**FINAL
FEASIBILITY STUDY REPORT
FORMER CAMP CROFT
SPARTANBURG, SOUTH CAROLINA**

Contract No.: W912DY-10-D-0028
Task Order No.: 0005

**UNITED STATES ARMY ENGINEERING AND SUPPORT CENTER,
HUNTSVILLE**

**UNITED STATES ARMY CORPS OF ENGINEERS,
SAVANNAH DISTRICT**

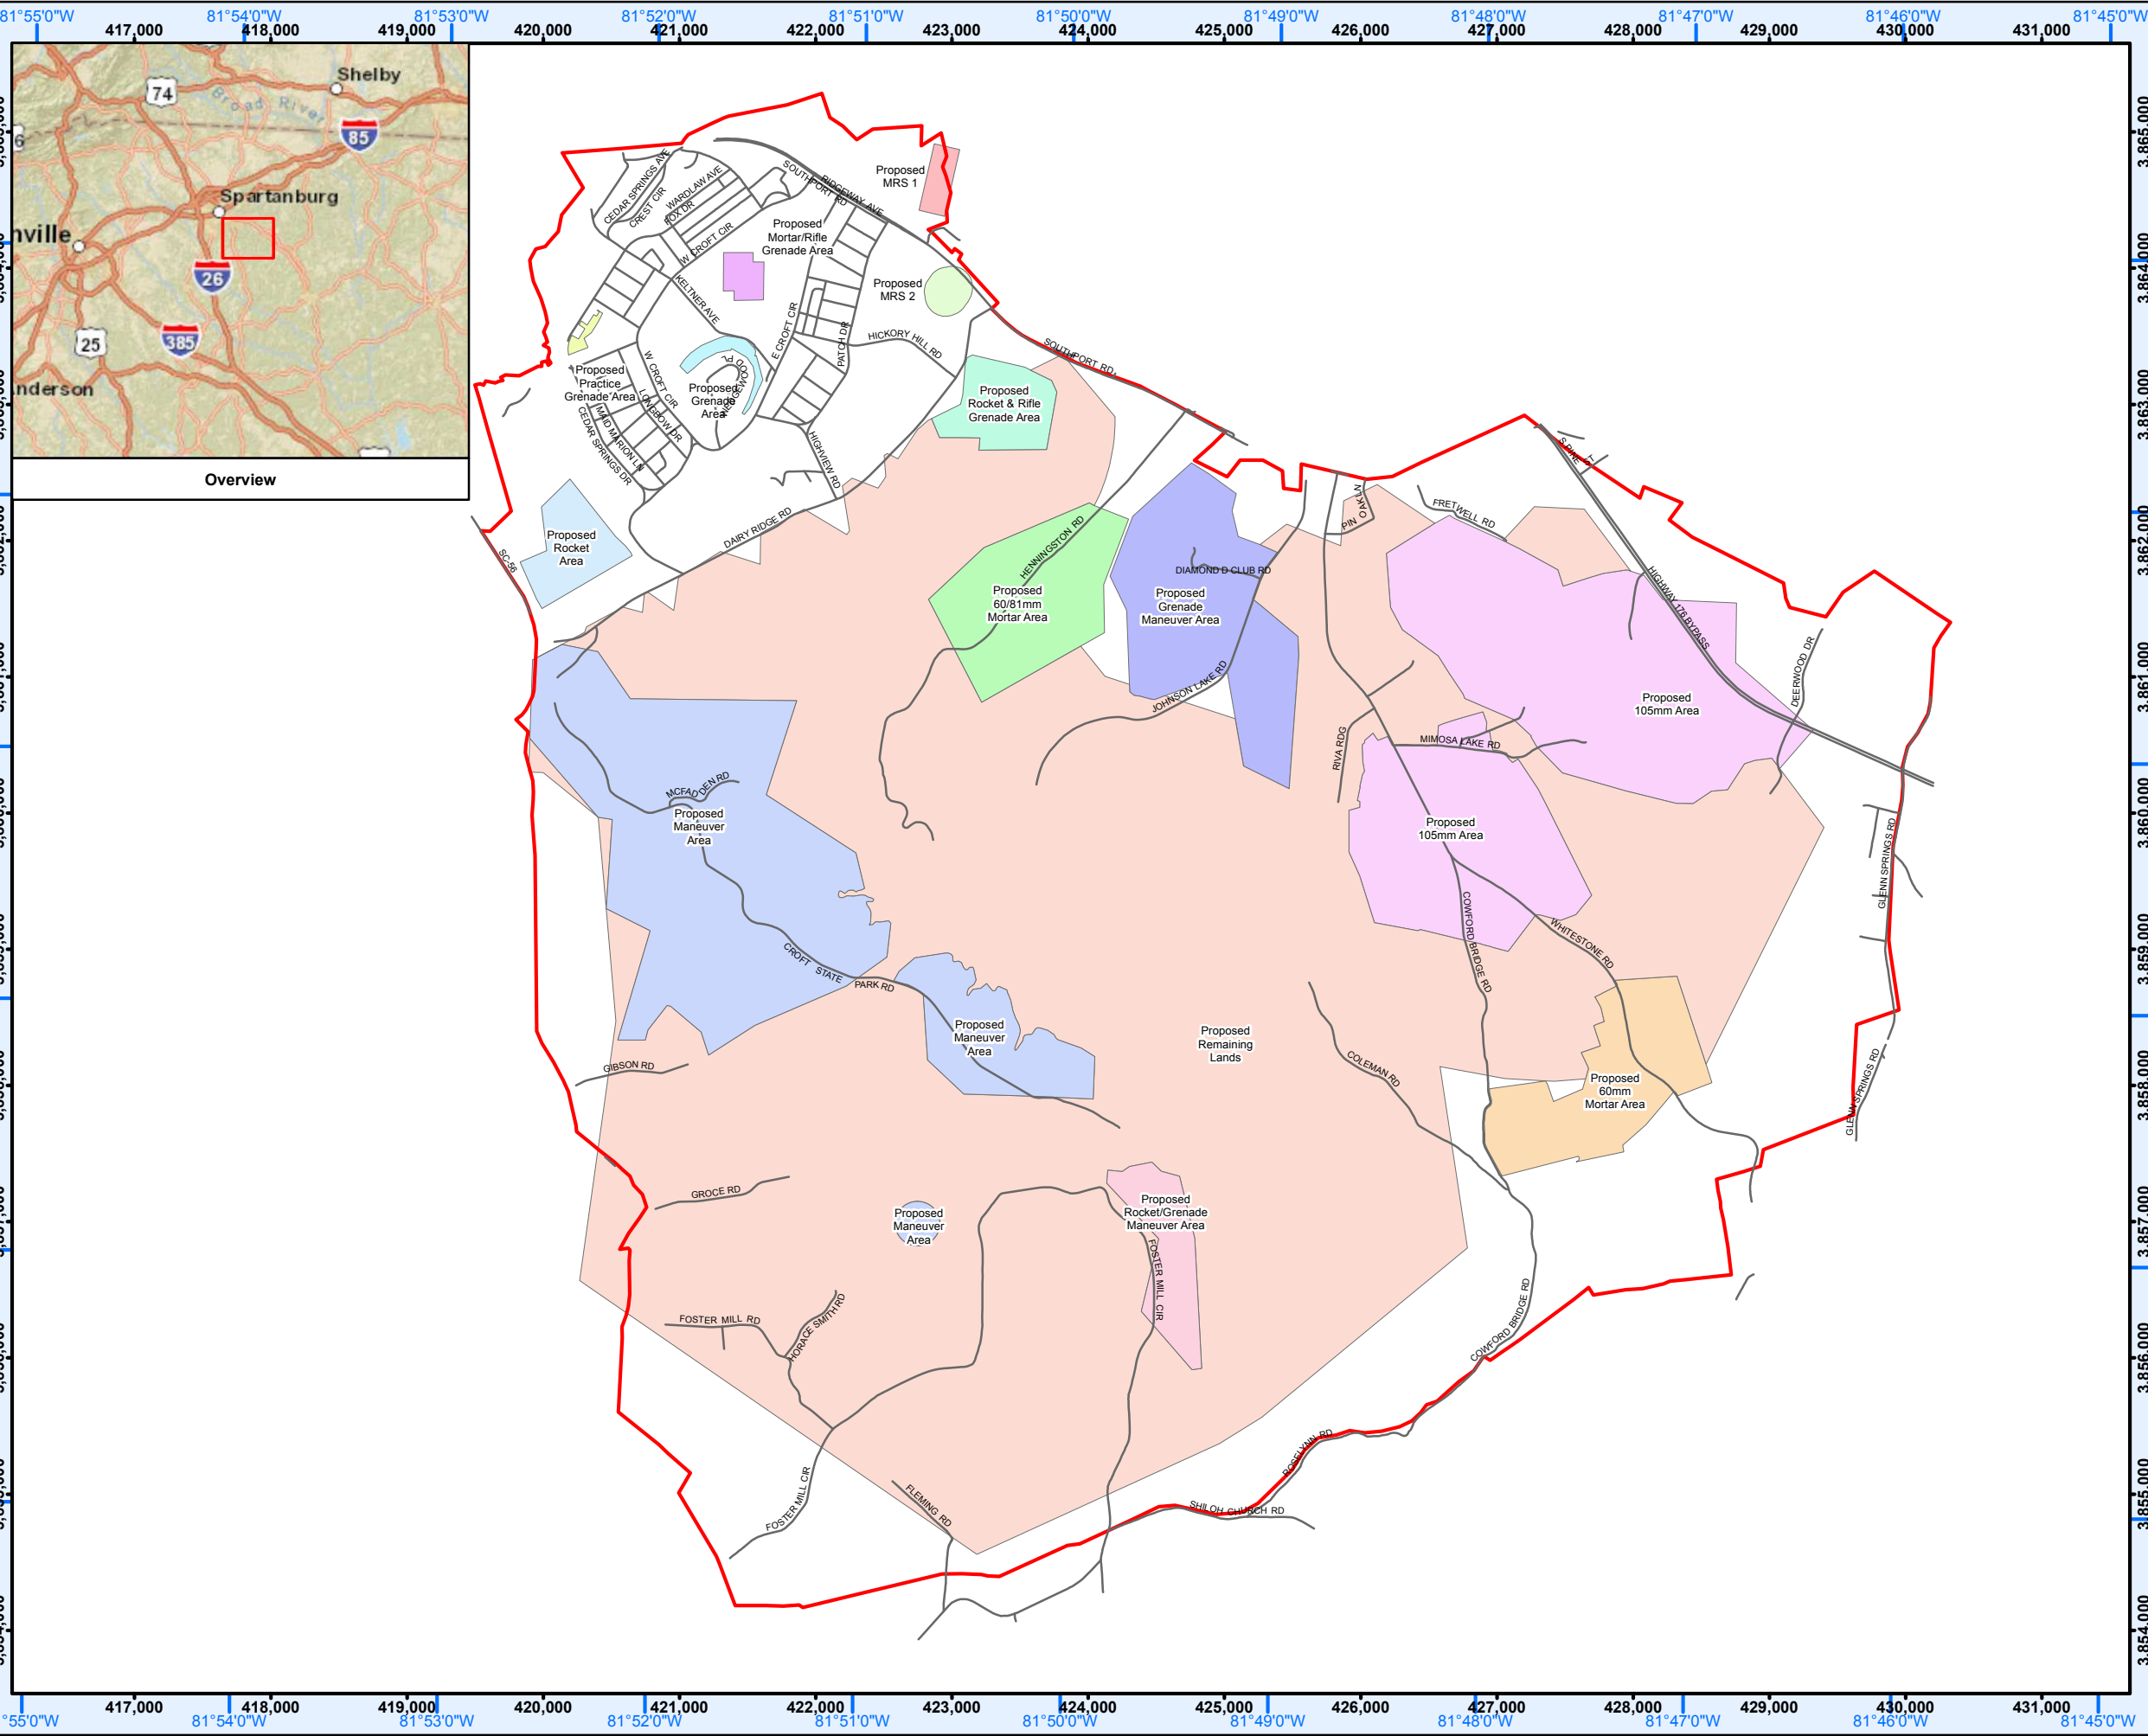
| UniquelD | Comment_Type | Global_Comment | Section | Page | Line | Reviewer | Discipline | Comment | Recommendation | Citation | Ref_Docs | Response |
|--------------|--------------|----------------|-----------------|------|------|--------------------|-------------------|---|---|----------|----------|--|
| 77666-JAS-3 | Significant | No | Exhibit 1-1 | 1-2 | | Sikes, John | MEC Response | The key to this exhibit lists different areas by former use and also includes two named MRS's; MRS 1 and MRS 2. Going back to Dwayne Ford's comment on the RI report regarding the initiation of the delineation process (I see RTC to his comment simply said "noted"), what work has been done Up to this point I was concerned that the single stated RAO was incomplete and too generic (paragraph 1.3), which it is. However, the discussion in this section on PRG's actually contains almost all the RAO information. | District needs to respond with how they intend and when they intend to begin/complete the delineation process. This preferably should be done prior to the PP, but must be done prior to drafting of the decision | | | Concur. The District has been closely involved with the development of the proposed MRSs and has communicated to the project PDT that updates to FUDSMIS are imminent. The Contractor will support those efforts, where necessary. |
| 77666-JAS-4 | Observation | No | 1.2.1.2 | 1-3 | | Sikes, John | MEC Response | Not clear to me in line 6 what you are referring to by "former" MRS 3; I don't see that area listed on the previous Exhibit 1. | Recommend clarifying where this area is, or correct the name here. According to FUDSMIS there is still only a single MRS. | | | Concur. The reference to MRS 3 in Section 1.2.1.2 was removed; it provided little value. Section 1.2.3.1 was greatly expanded, to explain how the single MRA identified in FUDSMIS was investigated during the RI and subsequently delineated into smaller proposed MRSs, which are being updated in |

1. As discussed in the Remedial Investigation (RI) report, the “Proposed Remaining Lands” is the area of MRS 3 not included in other proposed area realignments. Please provide a brief explanation of the other remaining land within the former Camp Croft boundary (areas not shared within the boundary in Exhibit 1-1) and how these areas have been addressed or why they are excluded.

| Review - Comment ID | Type/Status | EMCX Review Comment | EMCX Review Recommendation | Response to EMCX Review |
|-------------------------------------|-------------|--|---|--|
| Review Cycle: 1 UID: 77666-JAS-4 | Observation | Not clear to me in line 6 what you are referring to by "former" MRS 3; I don't see that area listed on the previous Exhibit 1. | Recommend clarifying where this area is, or correct the name here. According to FUDSMIS there is still only a single MRS. | Concur. The reference to MRS 3 in Section 1.2.1.2 was removed; it provided little value. Section 1.2.3.1 was greatly expanded, to explain how the single MRA identified in FUDSMIS was investigated during the RI and subsequently delineated into smaller proposed MRSs, which are being updated in FUDSMIS and referenced in the FS. Exhibit 1-1 was moved, to follow Section 1.2.3.1. |

Feasibility Study Report
 Former Camp Croft, Spartanburg, SC
 Remaining Lands (9,093.4 ac.)

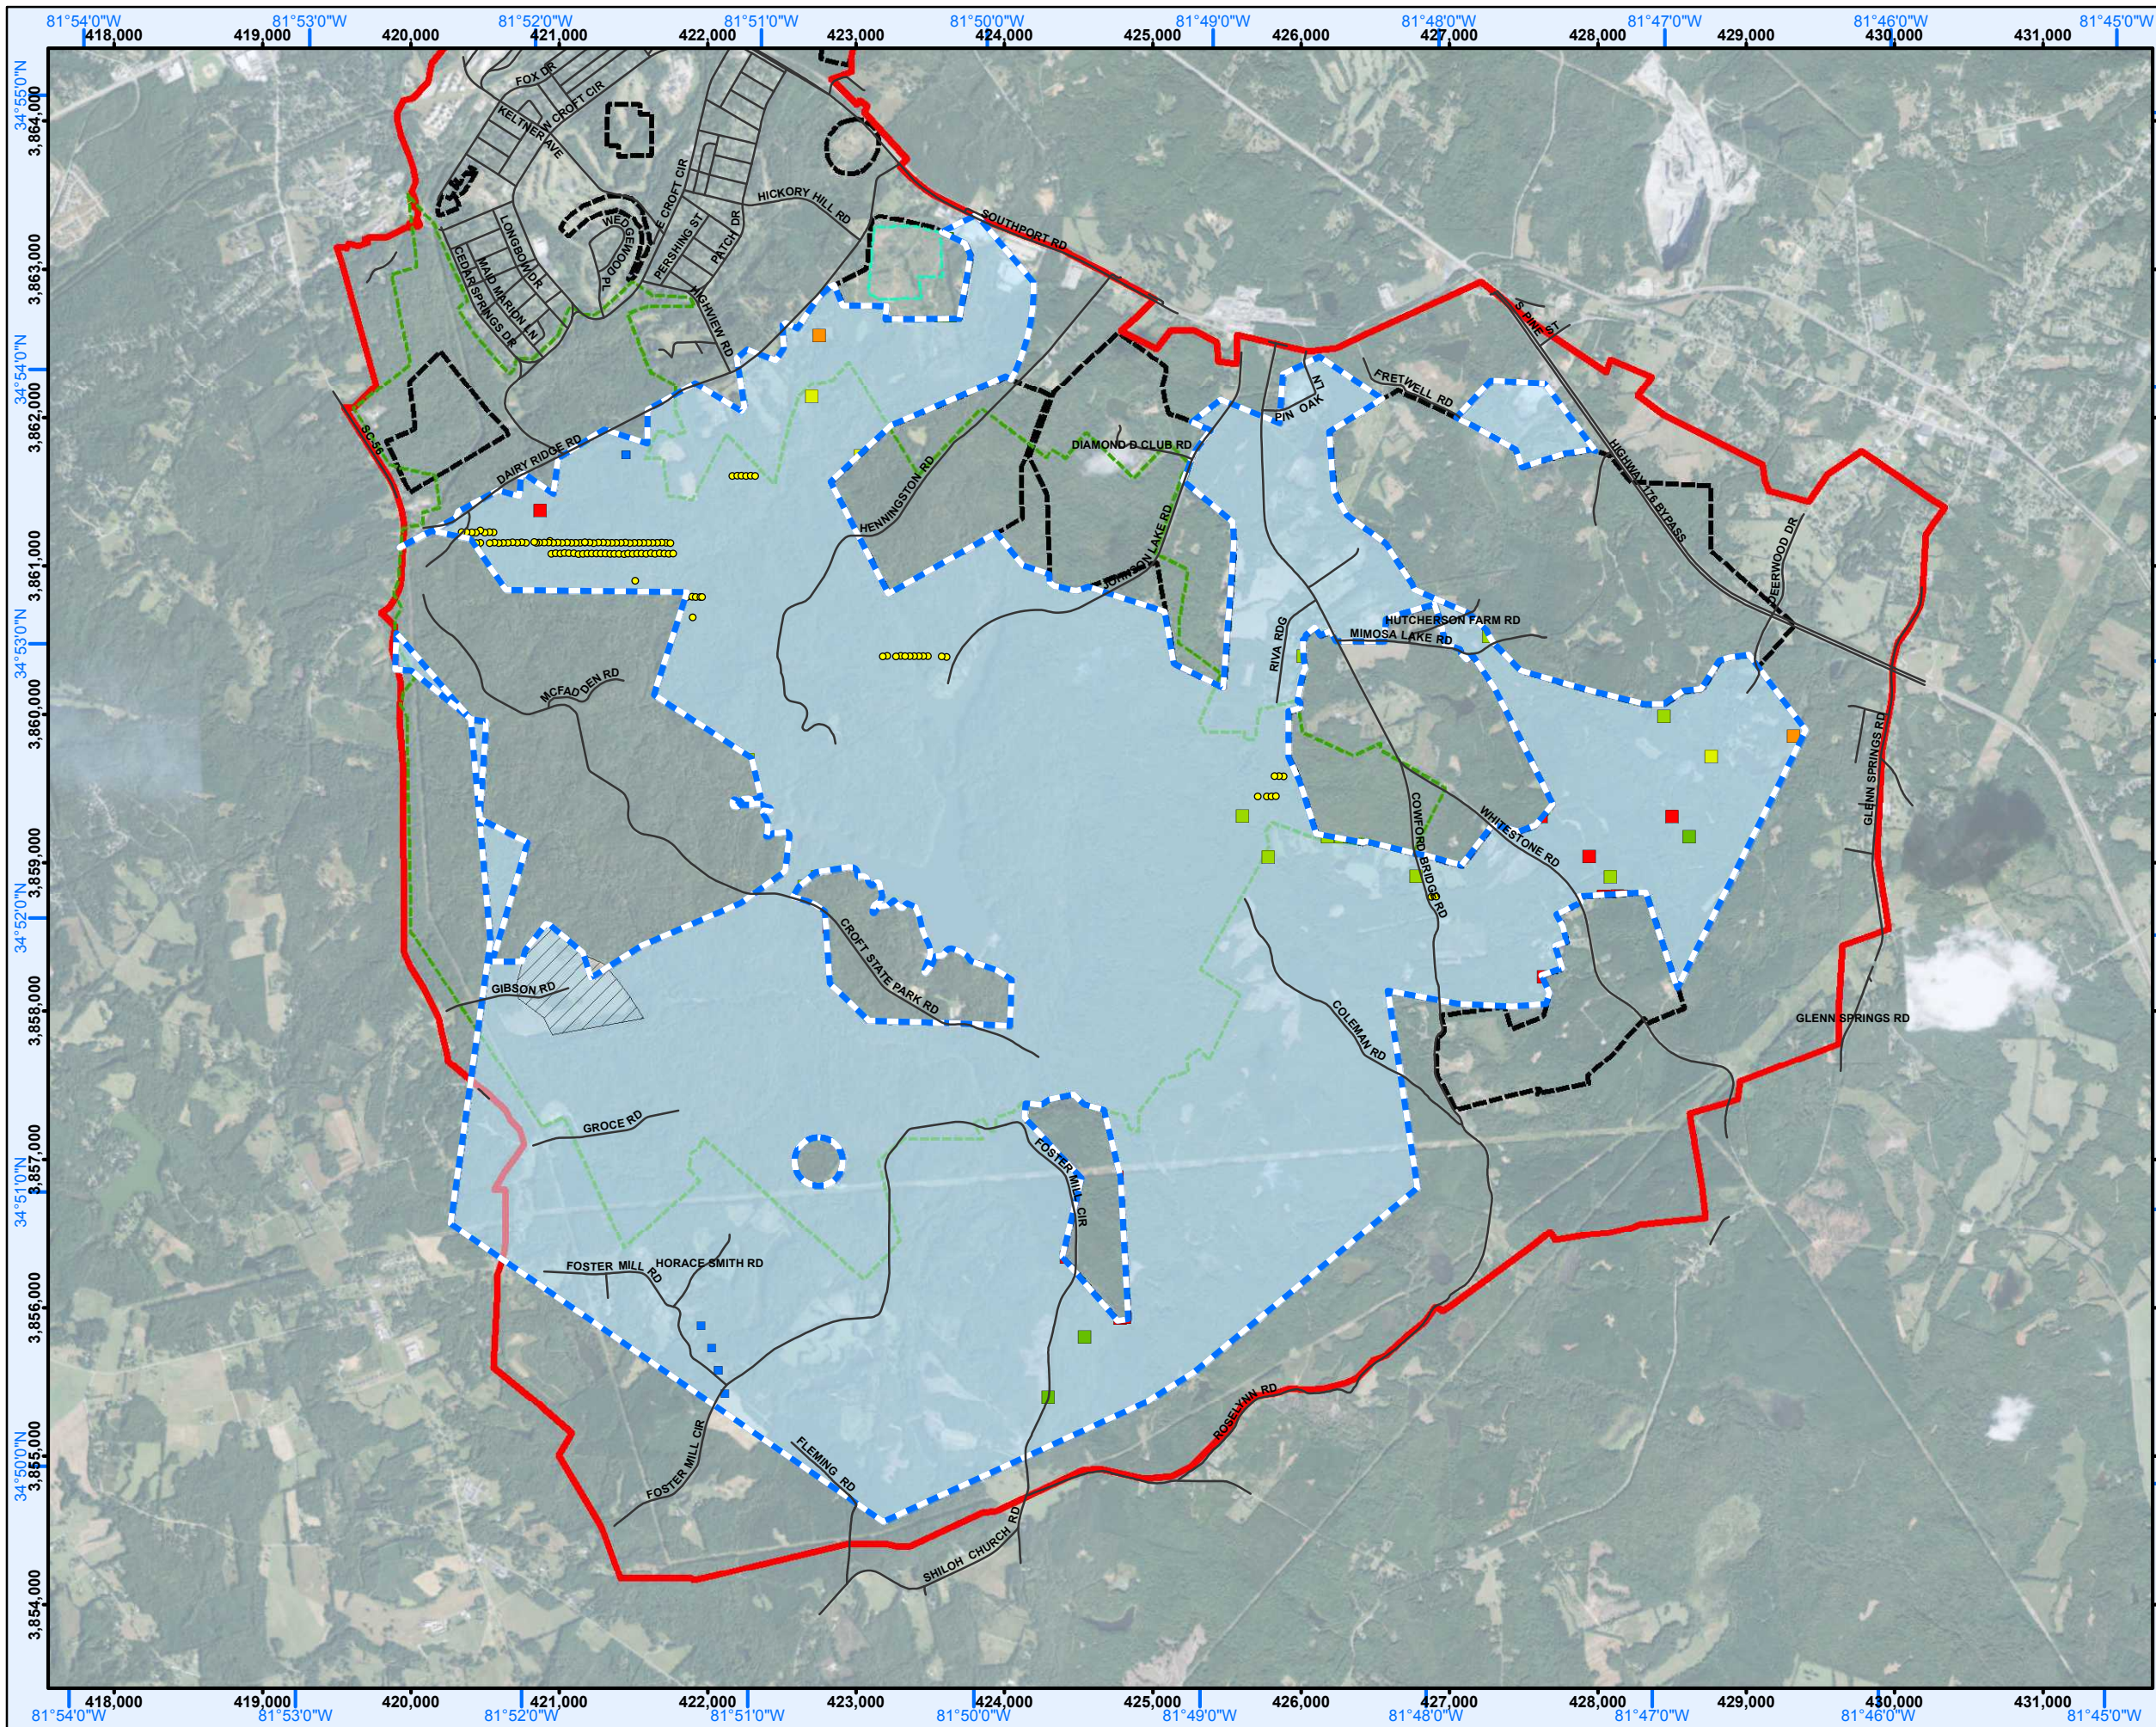
In an attempt to restate my initial concern, please provide the justification or rationale for why the “remaining lands” area boundary does not extend to the Camp Croft boundary leaving undesignated areas of the former Camp Croft that appear that they have not been addressed (i.e. Figure D-1: the unshaded, white area between the area boundary and Camp Croft boundary along the southern section or the large portion of the N/NW portion within the Camp Croft boundary). Another way to ask this may be why is this undesignated portions of land excluded from the “remaining lands” investigation?

SC DHEC Clarification (30 November 2015): In an attempt to restate my initial concern, please provide the justification or rationale for why the “remaining lands” area boundary does not extend to the Camp Croft boundary leaving undesigned areas of the former Camp Croft that appear that they have not been addressed (i.e., Figure D-1: the unshaded, white area between the area boundary and Camp Croft boundary along the southern section or the large portion of the N/NW portion within the Camp Croft boundary). Another way to ask this may be why is this undesigned portion of land excluded from the “remaining lands” investigation?

the FUDS, areas south of the range fans, and other miscellaneous areas) from the investigation. Following the data collection and analysis performed during the remedial investigation, areas boundaries were established (or refined) based on field evidence. For areas not included in the FS, like those referenced in SC DHEC's comment, the Department of the Army may initiate an investigation or response action, should additional information indicate a need for such, at any time in the future, subject to funding availability.
